Sun Fire™ V440 Server Product Notes

Part No. 816-7733-13
October 2003, Revision A

Sun Fire V440 Server

Product Notes

The Inner Glides and Slide Assemblies Incorrectly Illustrated

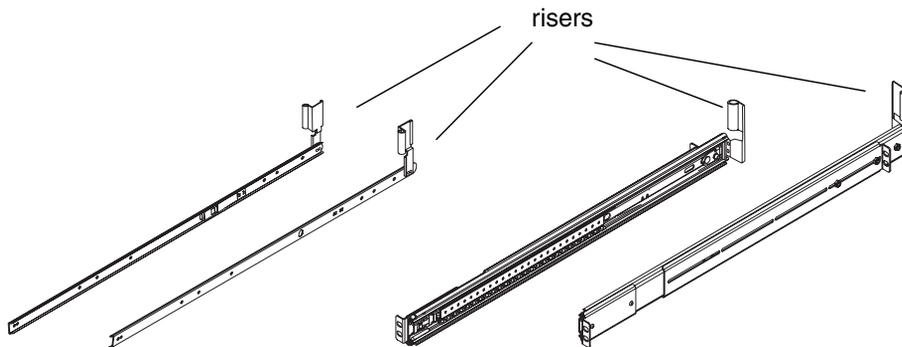
In the Sun Fire V440 server documentation set, the slide assemblies and inner glides used for rackmounting are incorrectly shown in the illustrations. The slide assemblies and inner glides have risers at the back ends that lift the cable management arm above the cable connectors. The illustration below shows the correct slide assemblies and inner glides.

Install the inner glides and slide assemblies so that the risers point up. Each piece is labeled “LEFT” or “RIGHT” to indicate where it should be installed, as viewed from the front of the server.
